# Access Compliance Report

## Public Rights-of-Way

### (Curb Ramps)

Intersection ID: 48139	Main Street: BEATY_CALDWELL_LN	Cross Street: WEDDINGTON_RD	Location: SE
ADA ID: 6093BC9F7C33	Ramp Type: Perpendicular	Initial Pass/Fail: Fail	Overall Compliance: No
		Severity Score: 8.75

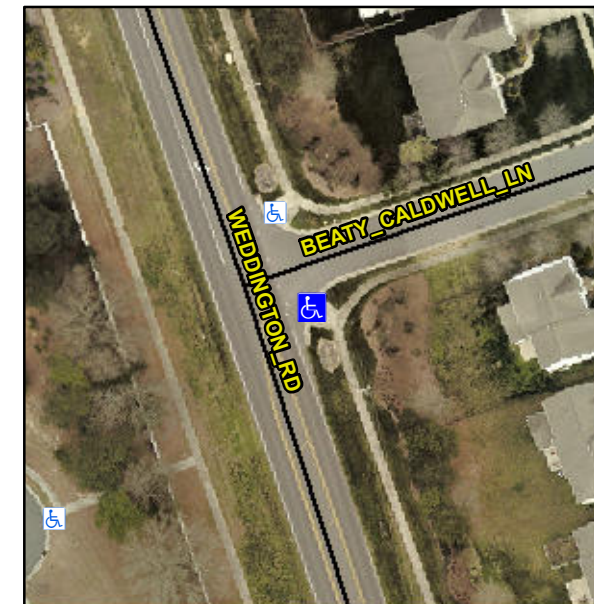
**R304.5.1**

Compliance	Description	Data	Compliance	Description	Data
N/A	Ramp Length (in)	152.5	Yes	Ramp Slope (%)	5.0
No	Ramp Width (in)	47.0	Yes	Ramp XSlope (%)	0.3
N/A	Flare Type LT	N/A	N/A	Flare Type RT	N/A
N/A	Flare Slope LT (%)	N/A	N/A	Flare Slope RT (%)	N/A
N/A	Flare Traversable LT?	N/A	N/A	Flare Traversable RT?	N/A
N/A	Landing Length (in)	N/A	N/A	DWS Provided?	N/A
N/A	Landing Width (in)	N/A	N/A	DWS Contrast?	N/A
N/A	Landing Slope (%)	N/A	N/A	DWS Length (in)	N/A
N/A	Landing X Slope (%)	N/A	N/A	DWS Full Width?	N/A
N/A	Landing Curb? (Y/N)	N/A	N/A	DWS Offset (in)	N/A
N/A	Shared Landing?	N/A			
N/A	Gutter Ponding?	N/A	N/A	Gutter Slope (%)	N/A
N/A	Gutter Lip Ht (in)	N/A	N/A	Gutter X Slope (%)	N/A
N/A	Painted X Walk1?	No	N/A	Painted X Walk2?	N/A
	X Walk 1 Direction	To N		X Walk 2 Direction	N/A
N/A	X Walk 1 Width (in)	N/A	N/A	X Walk 2 Width (in)	N/A
	X Walk 1 Slope (%)	0.6		X Walk 2 Slope (%)	N/A
	X Walk 1 X Slope (%)	0.4		X Walk 2 X Slope (%)	N/A

**Remove & Replace Entire Ramp.**
